Consideration of Comments

Project 2013-03 Geomagnetic Disturbance Mitigation

Figure 1. American Electric Power (AEP) Geomagnetically Induced Current Data Presented at February 2013 GMD Task Force Meeting

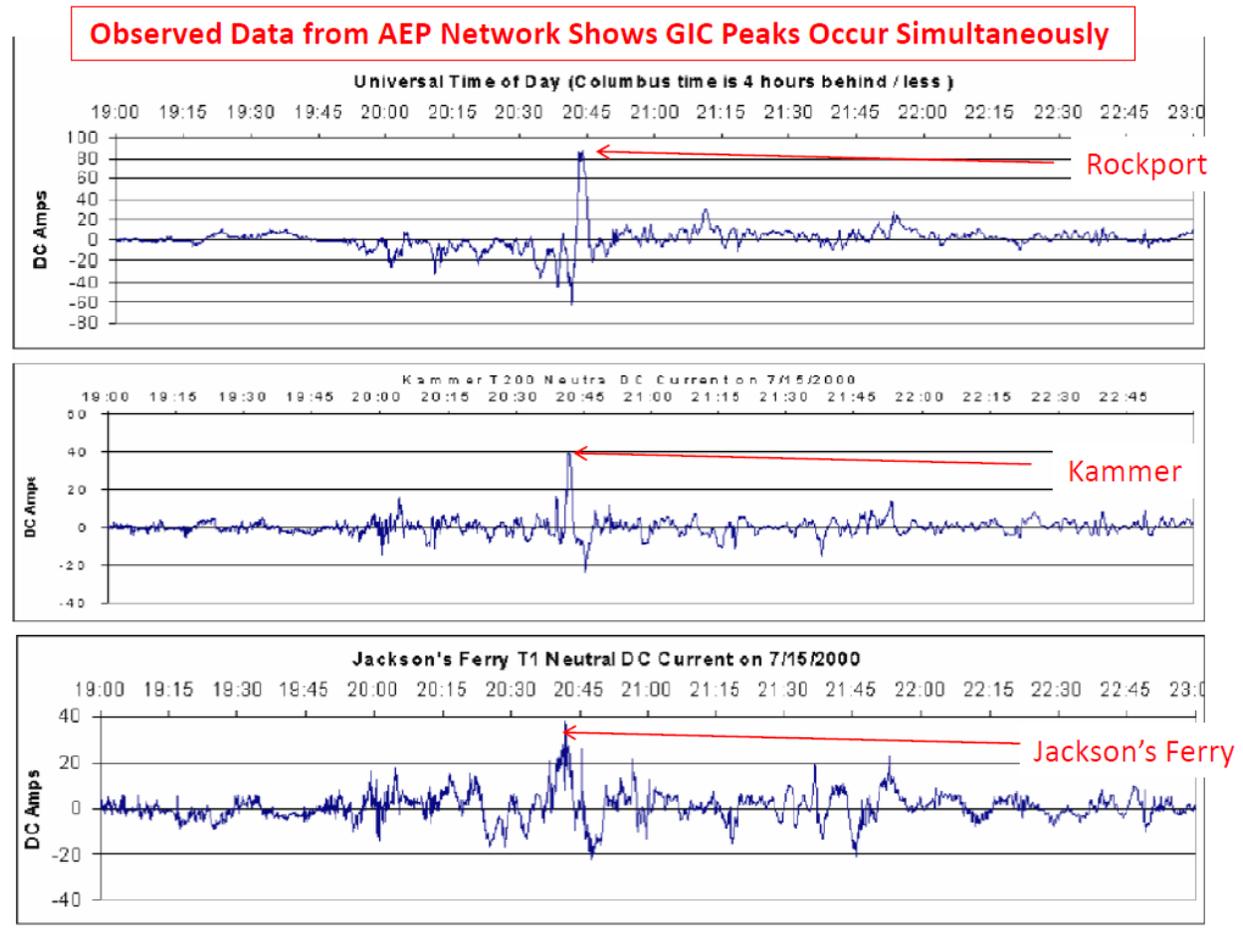
In this comment, we present data to show the NERC “hotspot” conjecture is inconsistent with real-world observations and the “Benchmark GMD Event” is therefore not scientifically well-founded.² Figures 1 and 2 show simultaneous GIC peaks observed at three transformers up to 580 kilometers apart, an exceedingly improbable event if NERC’s “hotspot” conjecture were correct.

Figure 3. Magnetometer Readings Over Time from Ottawa and St. John Observatories

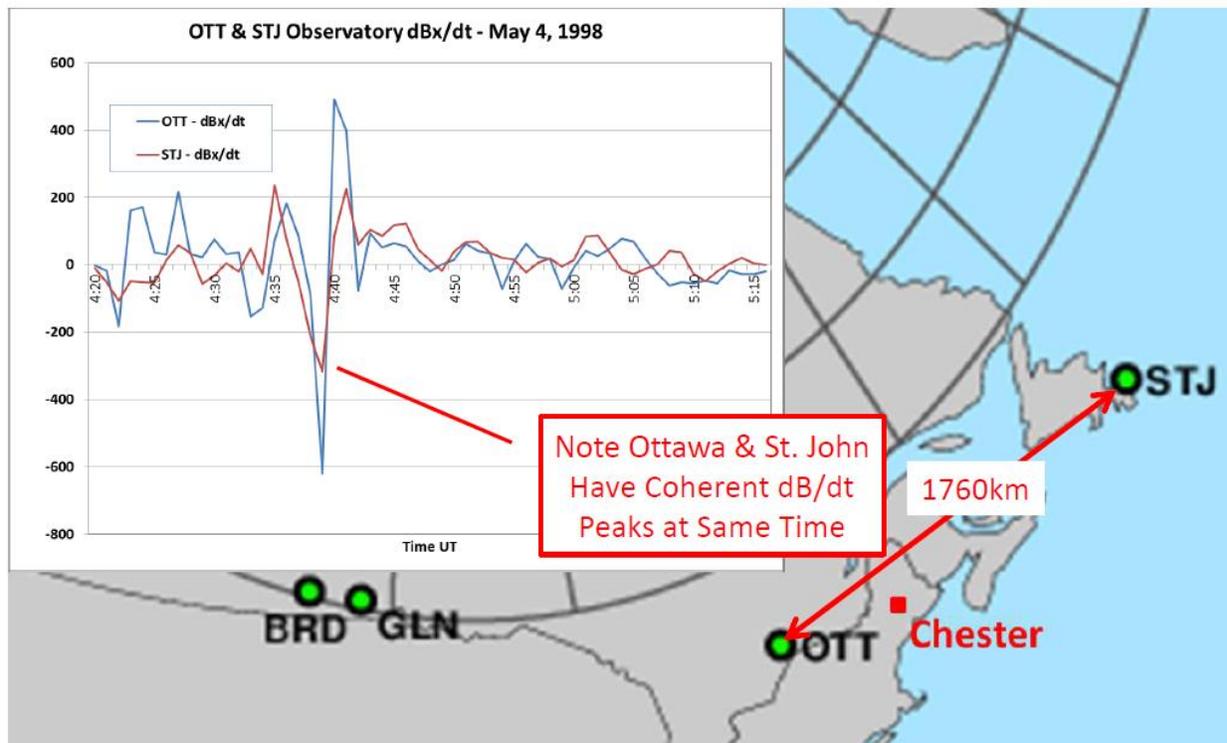
According to Faraday’s Law of induction, geomagnetically induced current (GIC) is driven by changes in magnetic field intensity (dB/dt) in the upper atmosphere. If dB/dt peaks are observed simultaneously many kilometers apart, then it would follow that GIC peaks in transformers would also occur simultaneously many kilometers apart. Figure 3 shows simultaneous dB/dt peaks 1,760 kilometers apart during the May 4, 1988 solar storm.

Figure 1 - NERC Proposed Profile of Geomagnetic Disturbance Intensity versus Geomagnetic Latitude

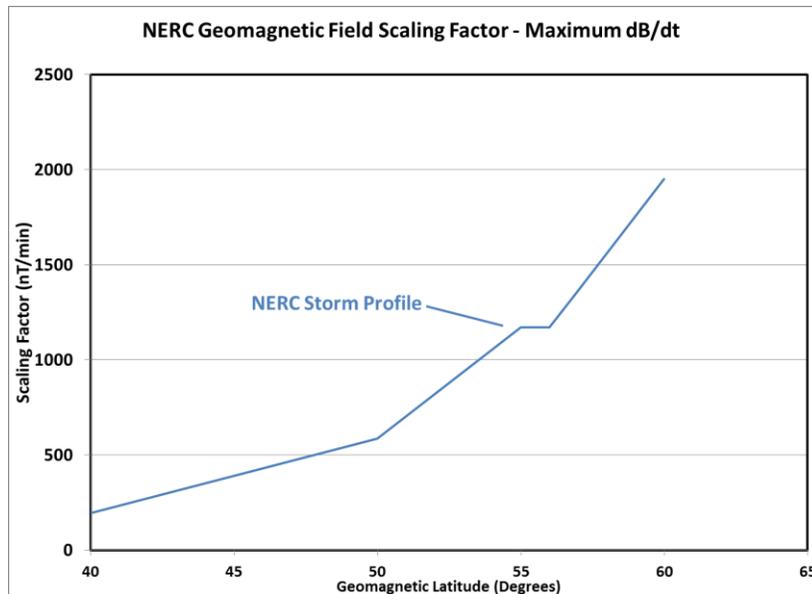
Figure 1 provides a graphic illustration of the NERC Standard proposed geomagnetic field intensity in nT/min, adapted from Table II-1 of α "Alpha" scaling of the geomagnetic field versus latitude across North America².

NERC has developed the intensity and profile described in Figure 1 from statistical studies carried out using recent data from the Image Magnetic observatories located in Finland and other Baltic locations³. This data base is a very small subset of observations of geomagnetic storm events, it is limited in time and does not include the largest storms of the modern digital data era and is limited in geography as it only focuses on a very small geographic territory at very high latitudes. The lowest latitude observatory in the Image array is at a geomagnetic latitude approximately equivalent to the US-Canada border, so this data set would not be able to explore the profile at geomagnetic latitudes below 55° and therefore reliably characterize the profile across the bulk of the US power grid. The NERC Reference Field excludes the possibility of a Peak disturbance intensity of greater than 1950 nT/min and further excludes that the peak could occur at geomagnetic latitudes lower than 60°. As observation data and other scientific analysis will show, both of these NERC exclusions are in error.

Figure 2 – NERC 100 Year Storm Reference Profile and Observations of dB/dt in 1972, 1982 and 1989 Storms that exceed the NERC Reference Profile

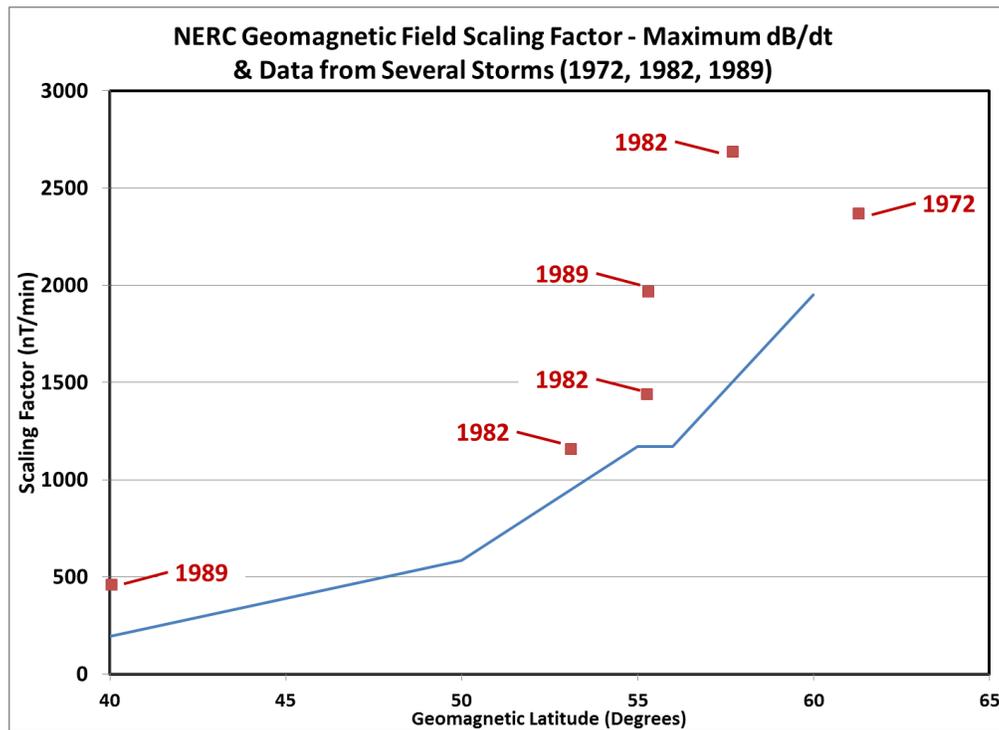
For the NERC Reference profile of Figure 1 to be considered a conservative or 1 in 100 year reference profile, then no recent observational data from storms should ever exceed the profile line boundaries. However as previously noted, the statistical data used by NERC excluded world observations from the large and important March 1989 storm and also from two other important storms that took place in July 1982 and August 1972, a time period that only covers the last ~40 years. In addition, data developed from analysis of older and larger storms such as the May 1921 storm have been excluded by NERC in the development of this reference profile. In just examining the additional three storms of August 4, 1972, July 13-14, 1982, and March 13-14, 1989, a number of observations of intense dB/dt can be cited which exceed the NERC profile thresholds. Figure 2 provides a summary of these observed dB/dt intensities and geomagnetic latitude locations that exceed the NERC reference profile.

As Figure 2 illustrates that are a number of observations that greatly exceed the NERC reference profile at all geomagnetic latitudes in just these three storms alone. The geomagnetic storm process in part is driven by ionospheric electrojet current enhancements which expand to lower latitudes for more severe storms. The NERC Reference profile precludes that reality by confining the most extreme portion of the storm environment to a 60° latitude with sharp falloffs further south. This NERC profile will not agree with the reality of the most extreme storm events. The excursions above the NERC profile boundary as displayed in Figure 2 clearly points out these contradictions.

Figure 3 – Comparison of NERC Peak at 55° Latitude versus Actual Observed dB/dt

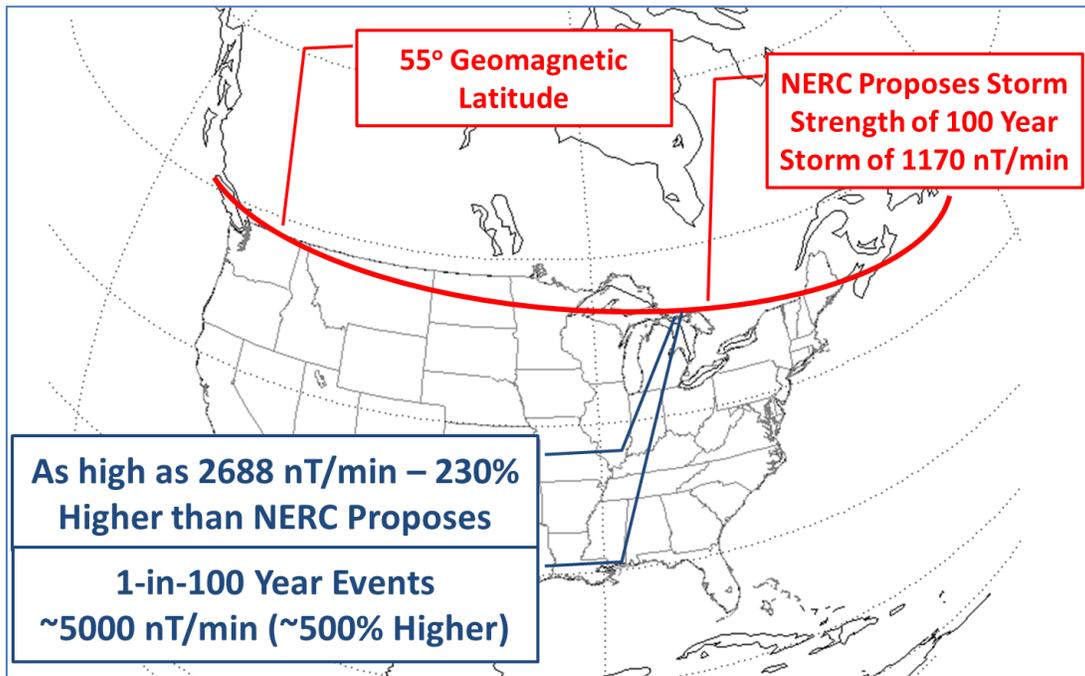
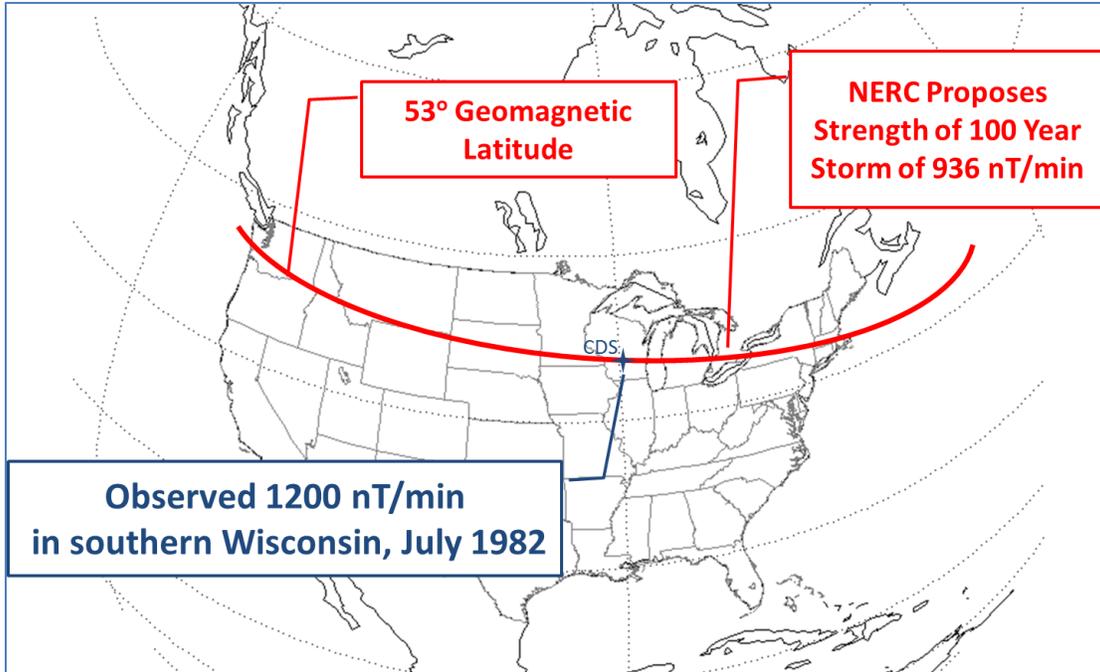
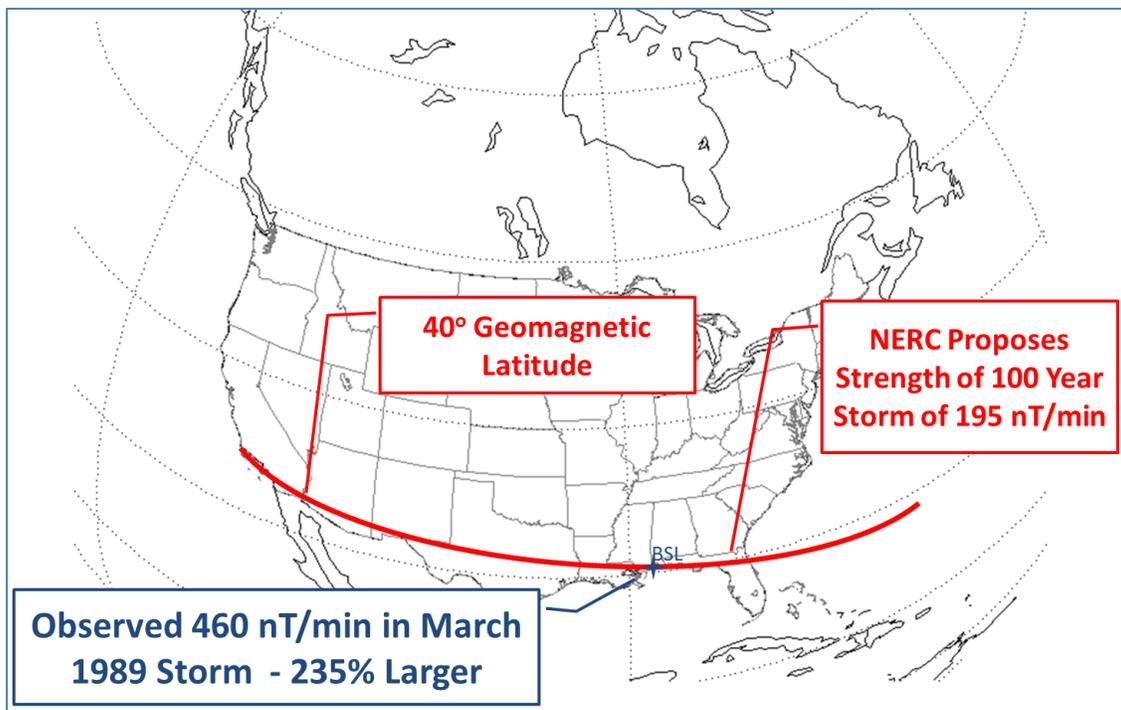
In terms of what this implies for the North American region, a series of figures have been developed to illustrate the NERC reference field levels at various latitudes and actual observations that exceed the NERC reference thresholds. Figure 3 provides a plot showing via a red line the ~55° geomagnetic latitude across North America which extends approximately across the US/Canada border. Along this boundary, the NERC Reference profile sets the Peak disturbance threshold at 1170 nT/min, but when

considering the three storms not included in the NERC statistics database, it is clear that peaks of ~2700 nT/min have been observed at these high latitudes over just the past ~40 years. As will be discussed later, it is also understood that extremes up to ~5000 nT/min can occur down to these latitudes. Figure 4 provides a similar map showing the boundary at 53° geomagnetic latitude across the US and per the NERC Reference profile, the peak threat level would be limited to 936 nT/min. Yet at this same latitude at the Camp Douglas Station geomagnetic observatory, a peak dB/dt of ~1200 nT/min was observed during the July 1982 storm. Figure 5 provides a map showing the boundary at 40° geomagnetic latitudes and the NERC Reference peak at this location of only 195 nT/min. This figure also notes that in the March 1989 storm the Bay St. Louis observatory observed a peak dB/dt of 460 nT/min, this is 235% larger than the NERC peak threshold.

Figure 6 – Scientific Estimates of Extreme Geomagnetic Storm Thresholds compared to Propose3d NERC Draft Standard Profile

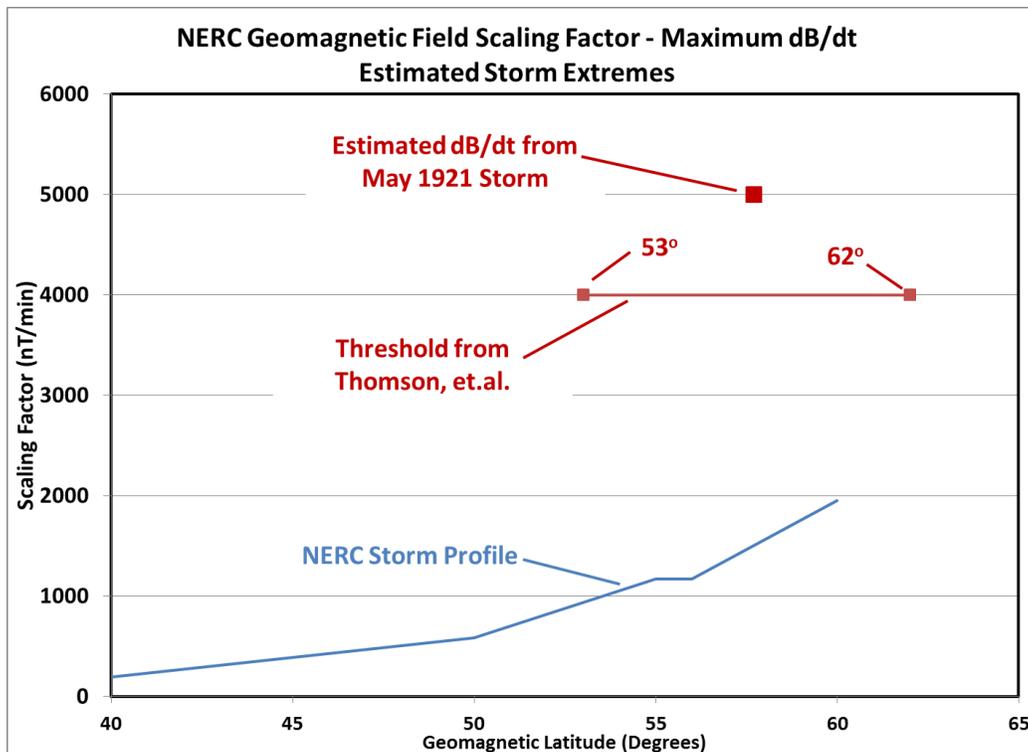
In summary, these storm observations limited to just three specific storms which happen to fall outside the NERC statistical database all show observations which exceed the NERC Reference profile at all latitudes. This illustrates that the NERC Reference profile cannot be a 1 in 100 year storm reference waveform and is not conservative. It should also be noted that even these three storm events are not representative of the worst case scenarios. In an analysis limited to European geomagnetic observatories, a science team publication concludes “there is a marked maximum in estimated extreme

levels between about 53 and 62 degrees north” and that “horizontal field changes may reach 1000-4000 nT/minute, in one magnetic storm once every 100 years”⁴. One advantage of this European analysis, it did not exclude data from older storms like the March 1989 and July 1982 storms, unlike in the case of the NERC database statistical analysis. In another publication the data from the May 1921 storm is assessed with the following findings; “In extreme scenarios available data suggests that disturbance levels as high as ~5000 nT/min may have occurred during the great geomagnetic storm of May 1921”⁵. In another recent publication, the authors conclude the following in regards to the lower latitude expansion of peak disturbance intensity; “It has been established that the latitude threshold boundary is located at about 50–55 of MLAT”⁶. It should be noted that one of the co-authors of this paper is also a member of the NERC Standards drafting team. All of these assessments are in general agreement and all call into question the NERC Reference Profile. Figure 6 provides a comparison plot of these published results with respect to the NERC Draft Standard profile and illustrates the significant degree of inadequacy the NERC Reference profile provides compared to these estimates of 100 Year storm extremes.

Figure 8 – Red Circles provide Region of Ground Model Validation using GIC observations from Kappenman/Radasky White Paper.

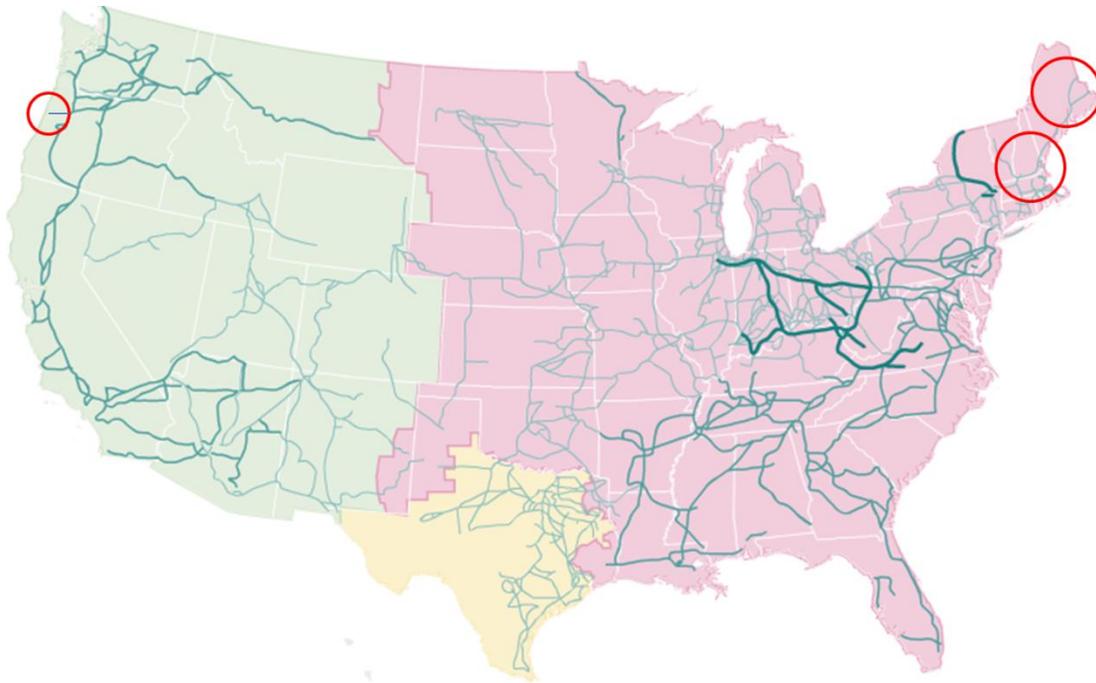
also known with high precision and many commercially available simulation tools can readily compute the GIC for a uniform 1 V/km geo-electric field. This calculation provides an intrinsic GIC flow benchmark that can be used to convert any observed GIC to an regionally valid Geo-Electric Field that produced that GIC. Further this calculation is derived over meso-scale distances on the actual power grid assets of concern. As summarized in a recent IEEE Panel discussion, this approach allows for wide area estimates of ground response than possible from conventional magneto-telluric measurements¹⁰. Figure 8 provides a map showing the locations of the Chester, Seabrook and Tillamook GIC observations and the approximate boundaries based upon circuit parameters of the ground region that were validated.

Figure 9 – GIC Observatories and US Grid-wide validation regions.

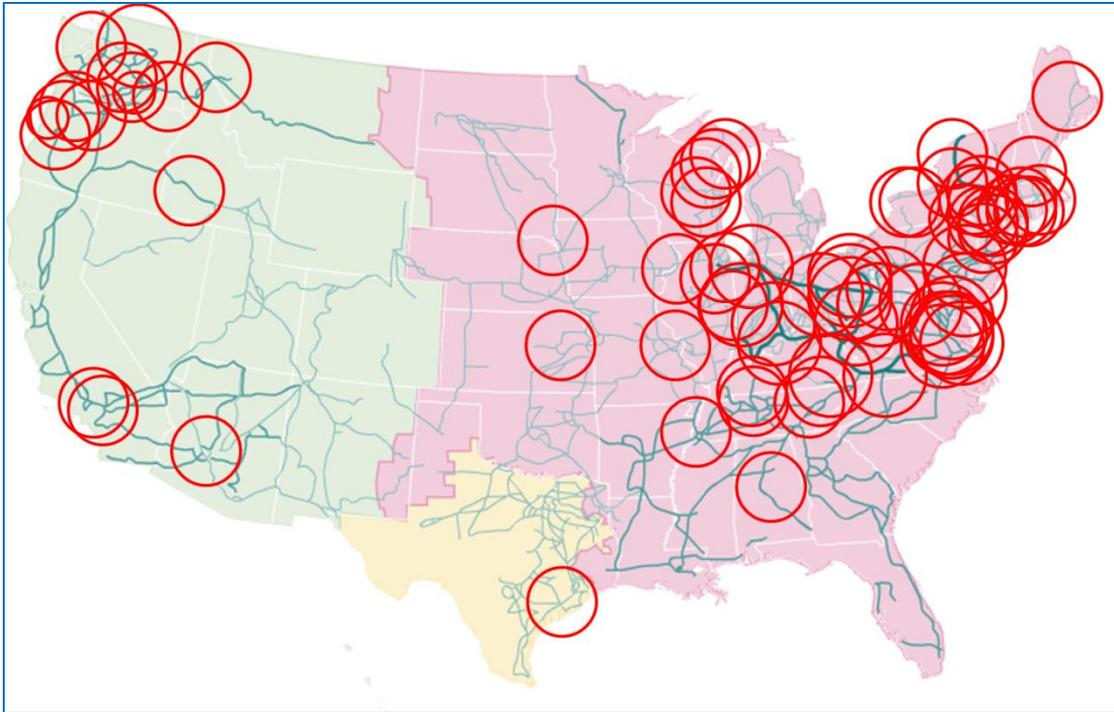
As filed in a recent FERC Docket filing¹¹, ~100 GIC monitoring sites have operated and are collecting data across the US. Using these analysis techniques and the full complement of GIC monitoring locations, it is possible to accurately benchmark major portions of the US as shown in the map in Figure 9. As shown in this figure, the bulk of the Eastern grid is covered and in many locations with overlapping benchmark regions, such that multiple independent observations can be used to confirm the accuracy of the regional validations. The same is also true for much of the Pacific NW. As noted in Meta-R-319 and shown below is Figure 10 from that report, these two regions are the most at-risk regions of the US Grid.
